Application No.	Applicant(s)		
Office Action Summary		10/615,991	PARK, CHEOL-JIN		
		Examiner	Art Unit		
		TUYEN T NGUYEN	2832		
The MAILING DATE of this communication appears on the cover sheet with the correspondence address Period for Reply					
THE - Exte after - If the - If NC - Failu Any	ORTENED STATUTORY PERIOD FOR REPL' MAILING DATE OF THIS COMMUNICATION. nsions of time may be available under the provisions of 37 CFR 1.1 SIX (6) MONTHS from the mailing date of this communication. e period for reply specified above is less than thirty (30) days, a repl period for reply is specified above, the maximum statutory period or tre to reply within the set or extended period for reply will, by statute reply received by the Office later than three months after the mailing ed patent term adjustment. See 37 CFR 1.704(b).	36(a). In no event, however, may a reply be ting within the statutory minimum of thirty (30) day will apply and will expire SIX (6) MONTHS from e, cause the application to become ABANDONE	nely filed s will be considered timely. the mailing date of this communication. D (35 U.S.C. § 133).

DETAILED ACTION

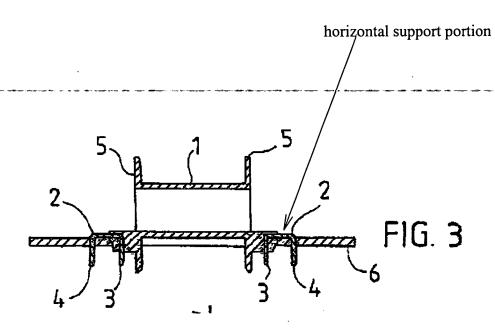
Applicant argues that there is simply no indication in Kataja that its connectors 2 having any support portions comparable to that recited in claim 1.

Examiner invite application to look at figure 3 below, horizontal support portion of pin [2], resting on the printed circuit board [6] providing the support function.
